Appl. No. 10/654,789 Amdt. Dated September 1, 2004 Reply to Office action of August 13, 2004

REMARKS

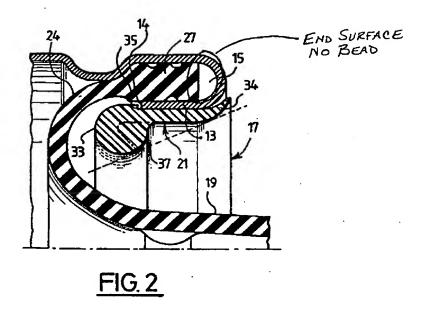
Directing the Examiner's attention to Figure 2 of the Moulinet patent, there is no disclosure of a bead on the end surface. Further, none of the additional Figures or the specification of the Moulinet patent disclose a bead on this end surface.

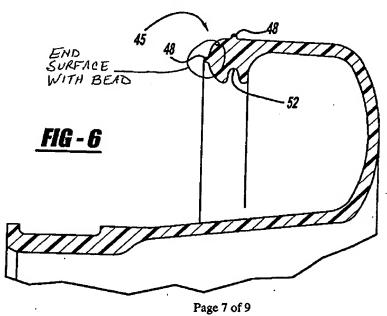
In contrast, referring to Figure 6 of the present application, the end surface includes a sealing bead (48). As claimed, the sealing bead is located on an end surface of the sealing area.
